Subject: RAI Response Clarifications
R.E. Ginna Nuclear Power Plant
Docket No. 50-244

The majority of clarifications were provided by letter dated July 11, 2003. Attachment 1 provides the remaining clarifications. Attachment 1 also provides clarifications and additions resulting from the NRC program audit, conducted June 23-25, 2003.

A regression analysis plot supporting the response to C-RAI 4.5-1 is provided as Attachment 2.
A design analysis supporting the response to C-RAI 4.7.4-1 is provided as Attachment 3.

Summary of Tendon Test Results 1981-2000

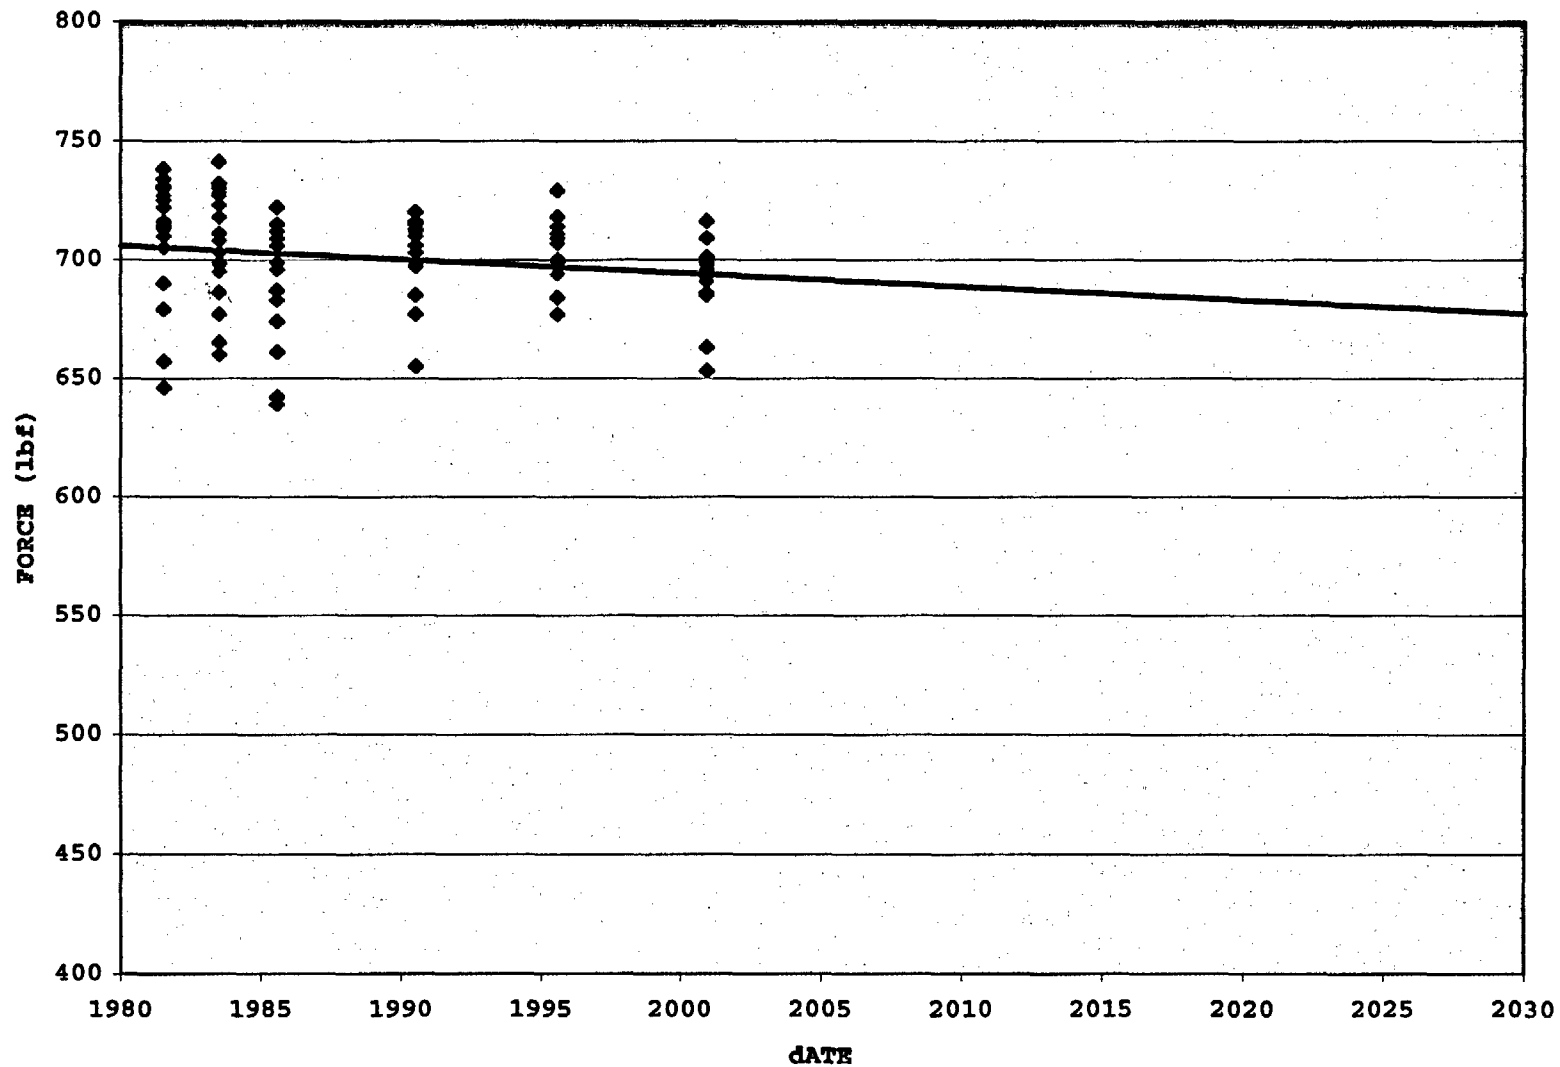
In constructing the trend lines, it appears that the analyst has averaged the prestressing forces measured during each inspection. In Information Notice 99-10, the staff discourages the averaging method. The regression analysis is more representative, if each measured value is independently considered in the regression analysis. The individual measured values plotted on both sides of the trend line would make the operating experience transparent. the applicant is requested to show the individual measured values obtained during each inspection.

A regression analysis, including the individual measured values obtained during each lift-ff test, we provide as Attachment 2.

Figure 3.8-18
Containment Miscellaneous Steel
Tendon Conduit - Hinge Detail

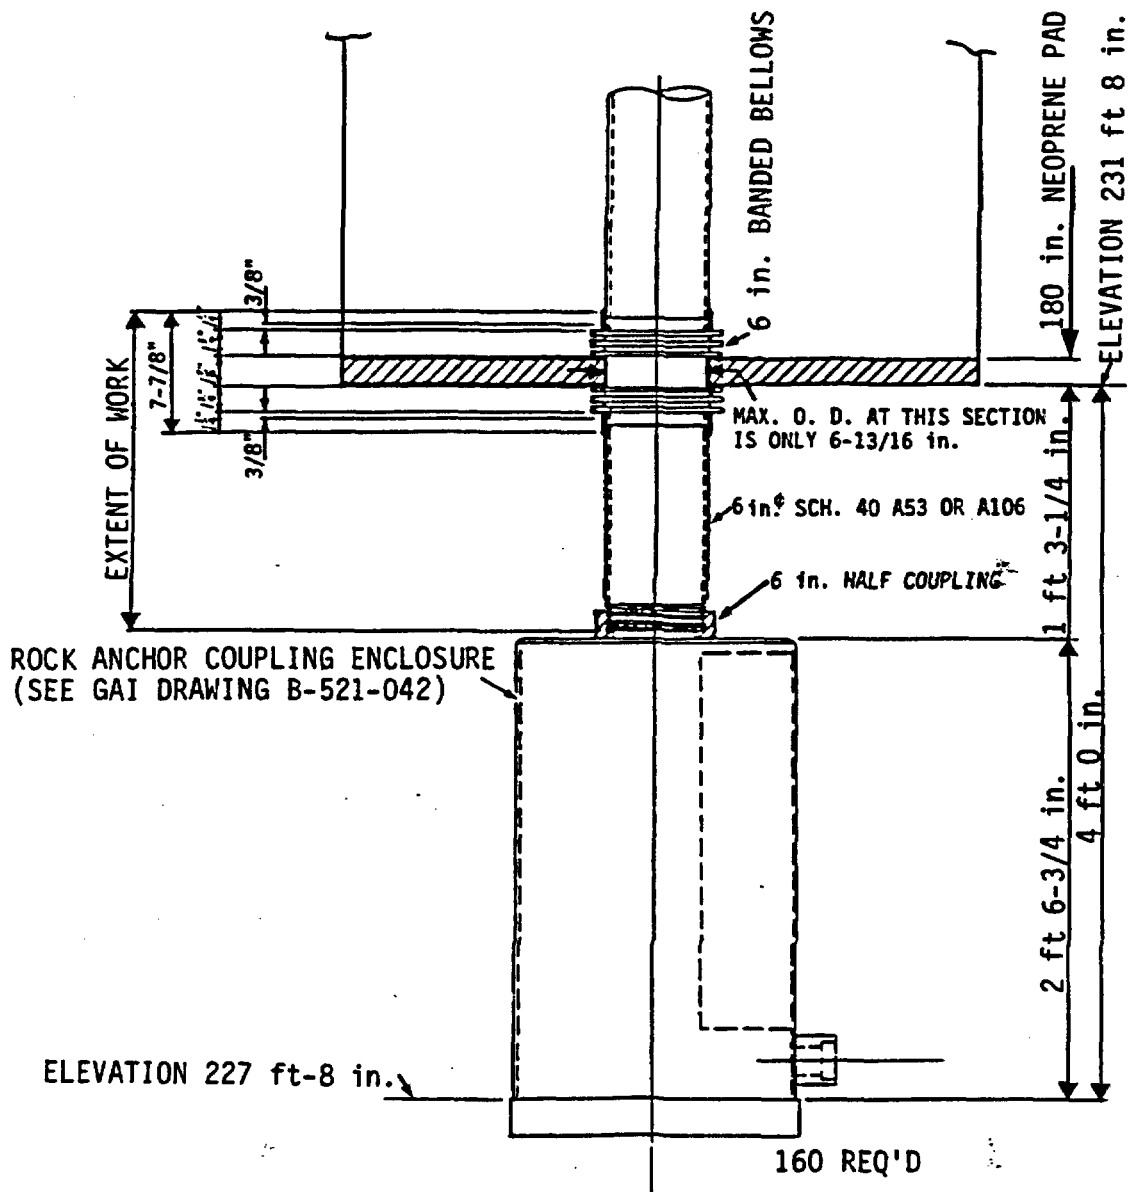
The applicant is requested to provide the bases for (1) 0.030 in (vertical), (2) 0.0014 (radial) displacements, and (3) 144 cycles used in the final fatigue usage factor calculations.

The bases for the (1) 0.030 inch (vertical), (2) 0.0014 inch (radial) displacements, and (3) 144 cycles used in the final fatigue usage factor calculations are contained in Attachment 3, Design Analysis DA-CE-202-016-07, Rev. 0, dated 6/22/02.

The allowable radial and vertical displacements of the containment stainless steel tendon bellows are given in UFSAR Figure 3.8-18 (Attachment 1) and are limited to two cycles per year for the 40 year life of the plant. This limits the total number of allowable displacement cycles to 80. Assume that 80 cycles of allowable displacement results in a fatigue usage factor of 1.0.

From ASME Code Figure N-415(B) for stainless steel (Attachment 4), the allowable alternating stress amplitude, S_a , for 80 cycles is 260 ksi. Assume that this is the peak stress produced in the bellows due to the combined effect of design basis vertical and radial displacements of 0.10" and 0.16" given in UFSAR Figure 3.8-18 (Attachment 1), and that this stress is directly proportional to the absolute sum of the displacements. Thus, $S_a = 260$ ksi is produced at an absolute displacement of 0.26".
